# OTHELLO SQUARE AFFORDABLE HOMEOWNERSHIP BUILDING

7343 MARTIN LUTHER KING JR WAY SOUTH  
SCDI PROJECT # 3027345

# DESIGN REVIEW RECOMMENDATION PROPOSAL PACKET

## REVIEW OF EDG COMMENTS

SITE PLAN

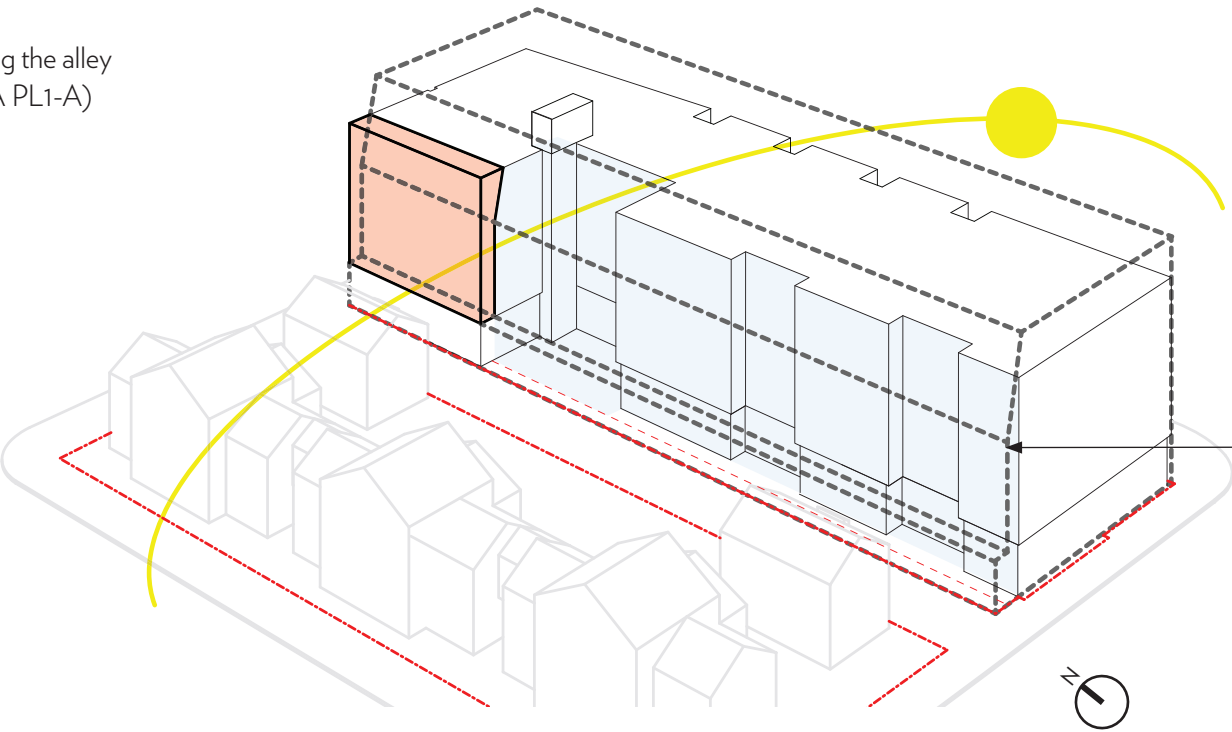
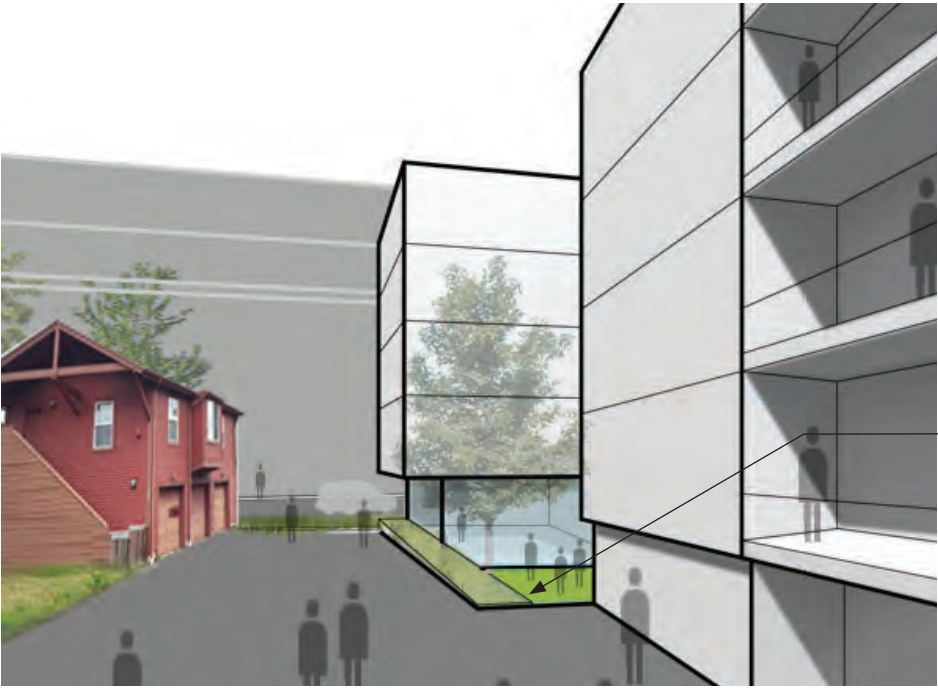
b. Related to the massing, the Board indicated unanimous early support of the upper setback departure request as the massing along the alley is oriented to improve solar access for the courtyard and the shared sundecks which the Board strongly supported. (CS1-B, CS2-A PL1-A)

**Design Guideline CS1-B Sunlight and Natural Ventilation**  
While the project requests upper setback departure at the north west corner, building massing at the south west side is held further away from the upper level setback requirement to allow better solar access to buildings across alley.

Voluntary setback beyond code minimum is proposed at south west portion of the building, along with courtyard

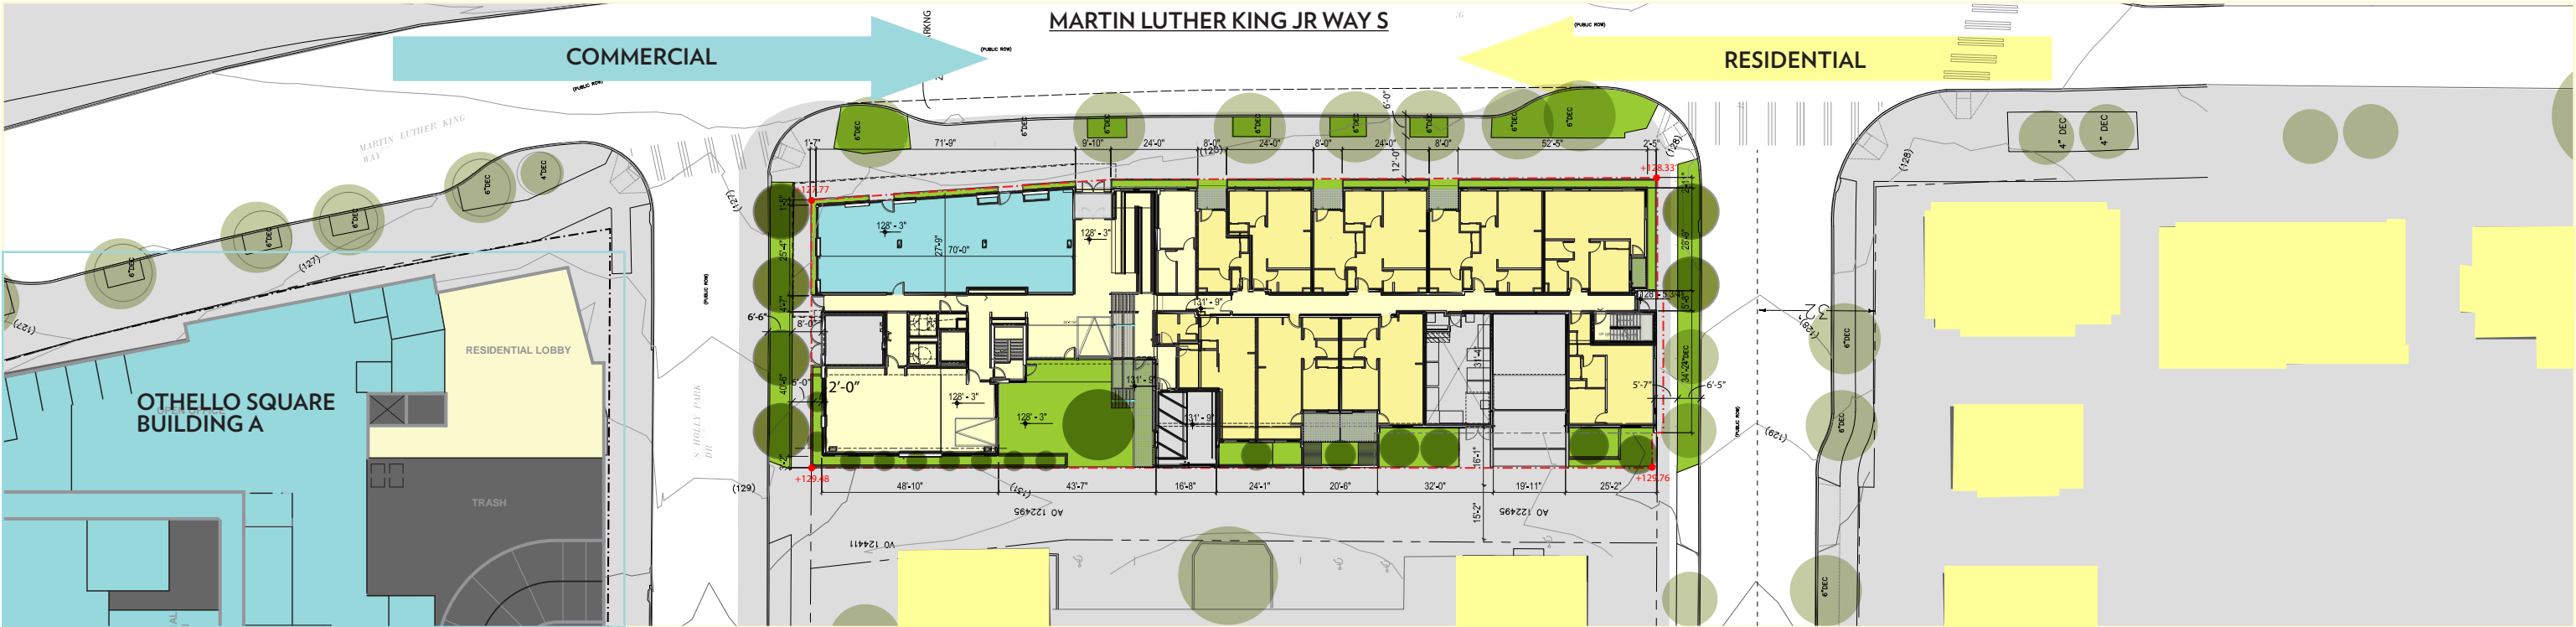
a. While the Board supported the arrangement of ground level uses overall, the Board recommended designing in the flexibility for the ground level residential units so that they can be adapted to individual commercial or office uses in the future. (PL3-B)

The inclusion of small commercial and office spaces for residents and the broader community is an important priority for Othello Square and was thoroughly studied in the master planning process. It was determined that these commercial and office uses will be contained within Building A, to the north of S Holly Park Drive, both as locations for small retail and commercial spaces, along with shared co-working space and small business assistance programs.

Additionally, with the current design, there is limitation on provision for stairs from the units down to the sidewalk grade. It's less than 3' between the edge of patios to the property line, which is not enough to provide 6 risers for the 3'-6" grade difference.

ROW SECTION - MLK JR WAY S.

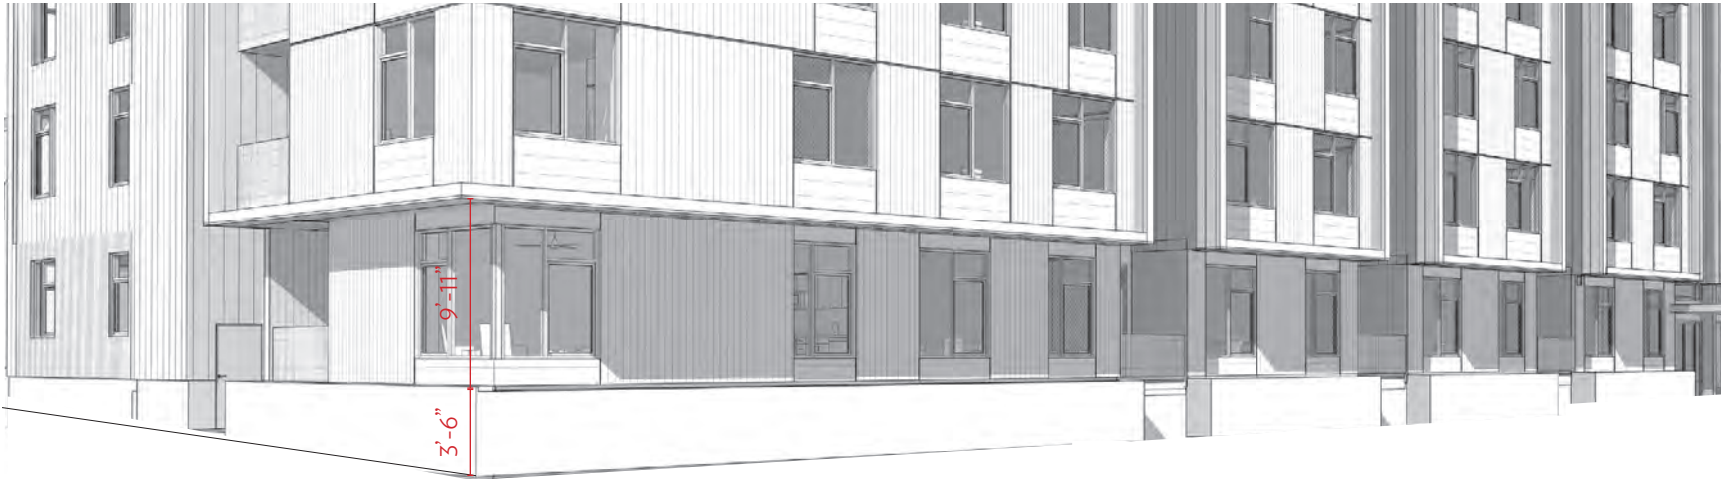
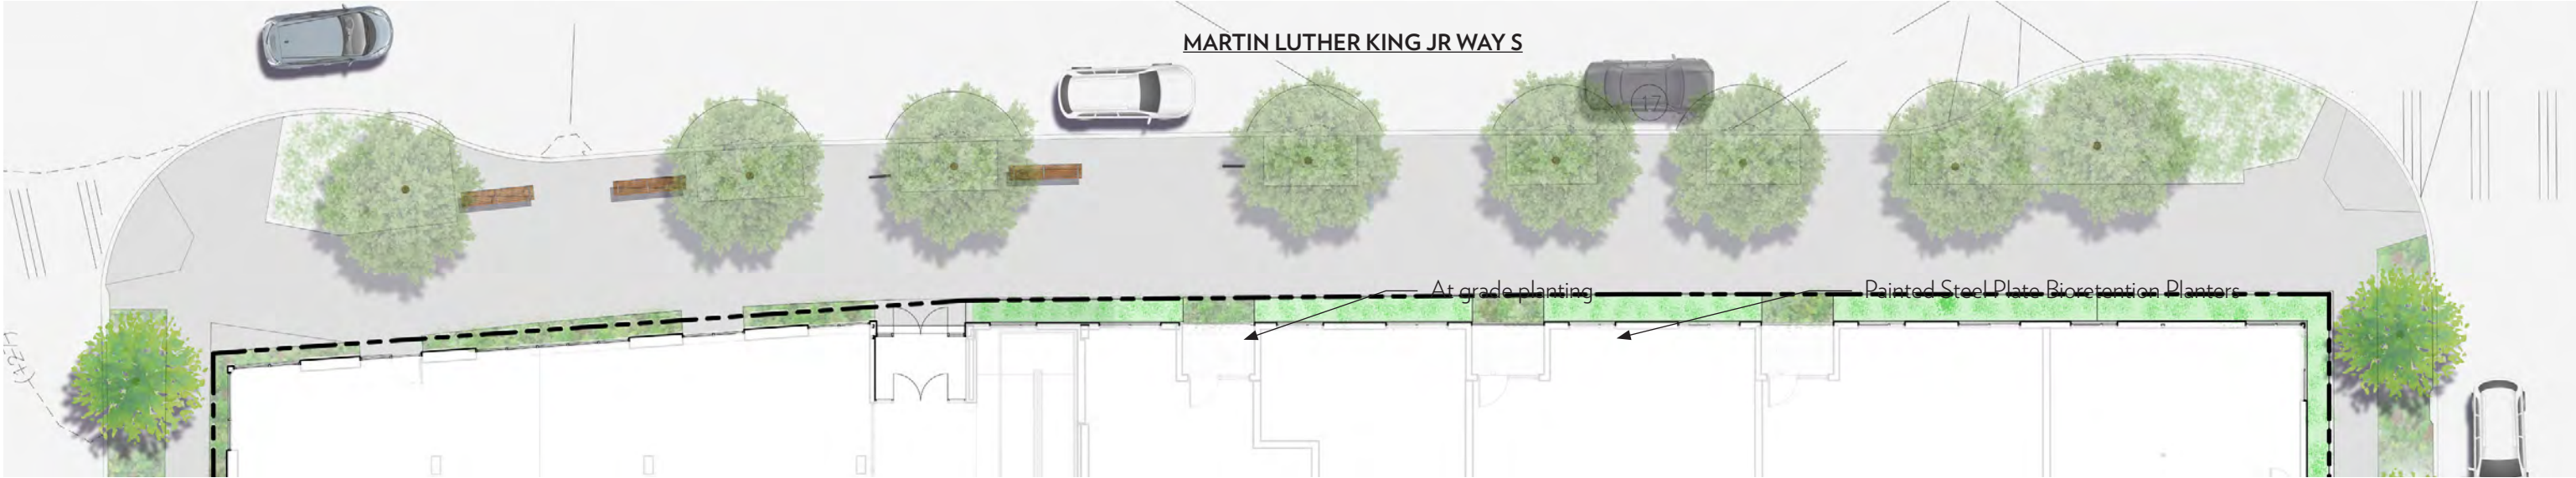
b. Related to the residential frontage, the Board indicated unanimous early support of the departure request to reduce the height of the residential frontage, to align the floor plate to the alley grade, and to reduce the amount of internal ramping for accessibility. The Board also supported the proposed direct entries to ground level units along the alley. For the street facing residential frontage, the Board recommended designing the bioretention planting to create a buffer for privacy and requested enlarged drawings of the streetscape design for the next meeting. (PL2-A, DC1-A)

For the MLK Way S facing residential frontage, bioretention planters capturing roof run offs have been designed to create a buffer between the pedestrian realm and the residential units. The planters are raised 3'-0" to 3'-6" above the adjacent sidewalk, which corresponds with the finish floor elevation of the adjacent residential units. This allows the plant material to provide both vertical visual interest and buffering between residents and pedestrians. Planters are broken up into segments just as the building massing behind. In between the biorentation planters, at-grade landscape creates a 2' wide green buffer between sidewalk and residential unit balconies that are at 3'-6" height off of the sidewalk.

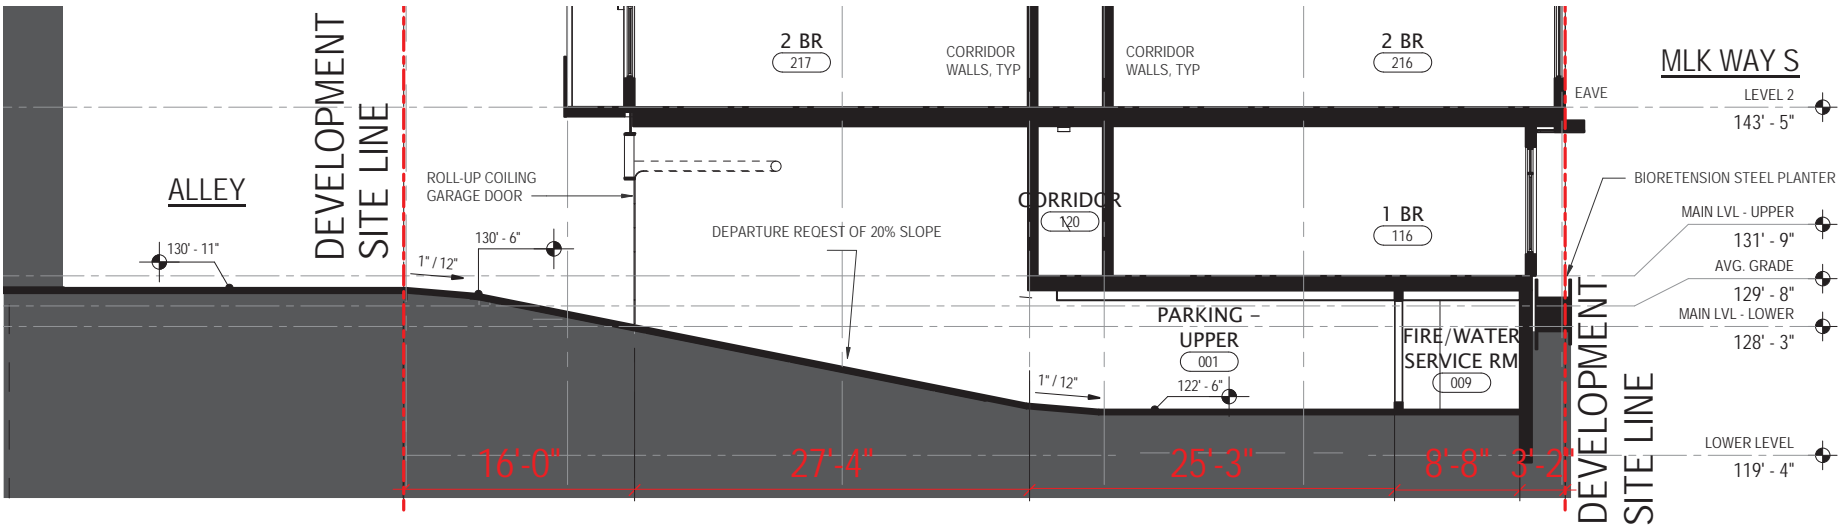
Departure Request #4	Code Requirement	Explanation For Departure and Applicable Design Guidelines
Departure is requested for the east-west average depth at $(29'-10'' + 24'-11'') / 2 = 27' - 4 \frac{1}{2}''$ at the Business space	<b>23.47A.008 B 3</b> Non-Residential Street Development Standards- Depth. Non residential uses shall extend average 30', minimum 15' from street face.	We propose the Business space at the north end of the property because it acts as a good transition from the commercial programs north of our site. It is also located at the corner of MLK Way and S Webster Street, which is frequently used by the public and visibly prominent along the street intersection, meeting <b>DC1-A-1</b> , Visibility. Due to the fact that the east property line narrows down at an angle towards north, we have a fairly narrow site to accommodate a Business space facing the prominent street frontage of MLK Way S. We also need to accommodate residential amenity space that connects to the Courtyard and also in close proximity to the main Othello Square for residents to be able to easily use both main campus amenities as well as onsite amenities, meeting <b>DC1-A-2</b> , Gathering Places.

EAST WEST SECTION THROUGH GARAGE RAMP

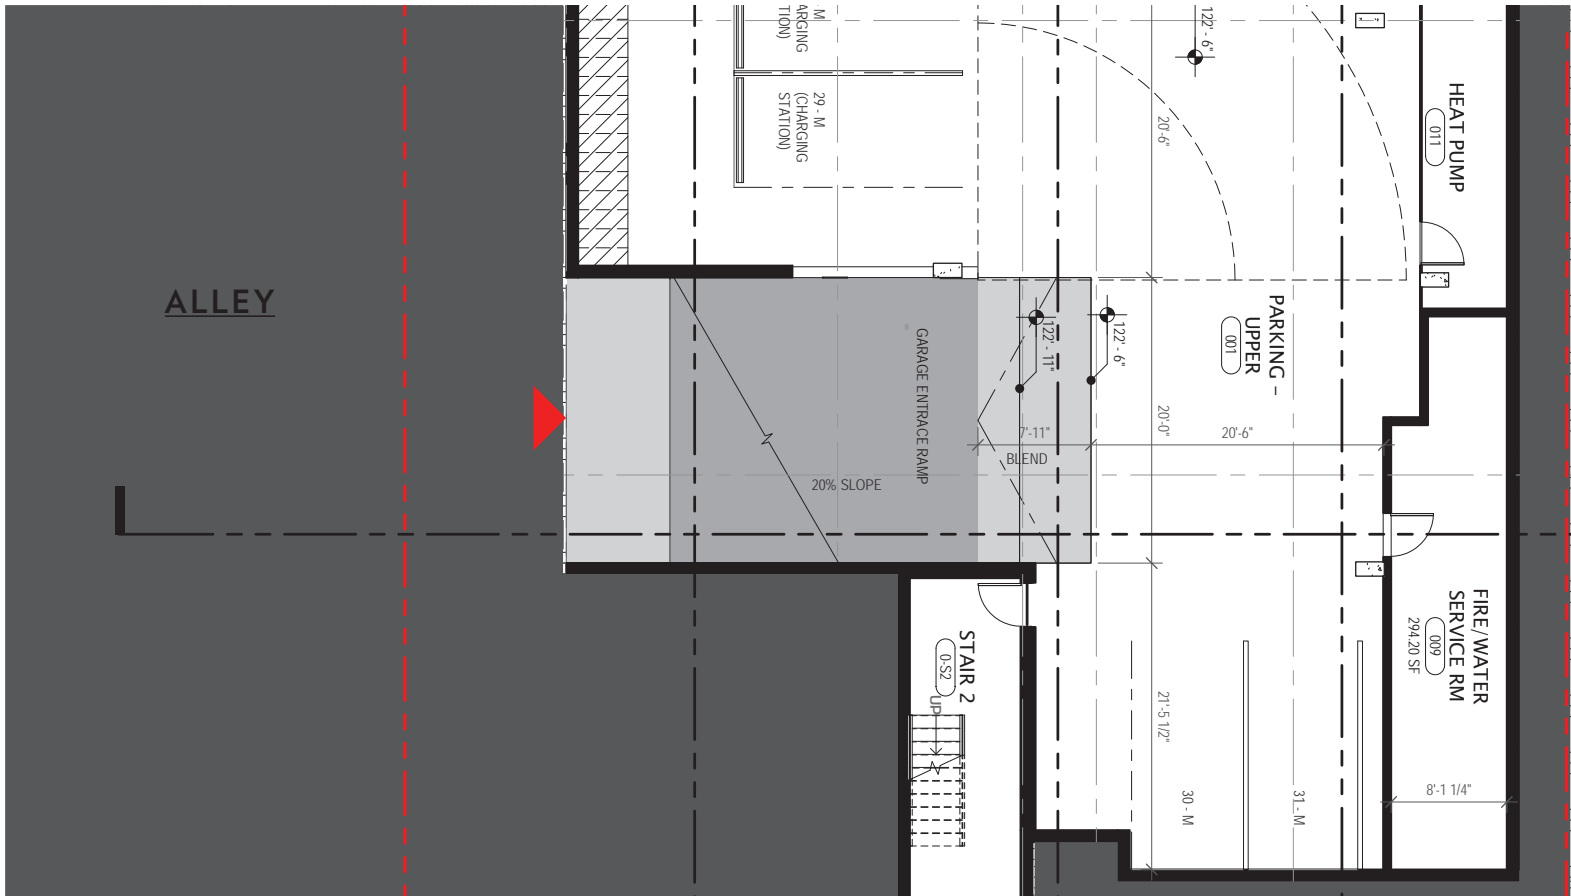
Departure Request #5	Code Requirement	Explanation For Departure
Departure requested for 19.79 percent slope for the parking entrance ramp with blends of 8 percent at the top and bottom of the ramp.	<b>23.54.030.D.3</b> Driveway slope for all uses. No portion of a driveway, whether located on a lot or on a right-of- way, shall exceed a slope of 15 percent. The maximum 15 percent slope shall apply in relation to both the current grade of the right-of-way to which the driveway connects, and to the proposed finished grade of the right-of-way if it is different from the current grade. The ends of a driveway shall be adjusted to accommodate an appropriate crest and sag.	We located the garage entry away from pedestrian crossings between our project and the main Othello Square campus, thus meeting <b>DC1-B-1</b> , Access Location and Design. SDOT also prefers parking entry from the alley. However, the narrow site width in east/west direction and limitation of residential unit layouts above, makes a 15 percent maximum driveway slope infeasible.
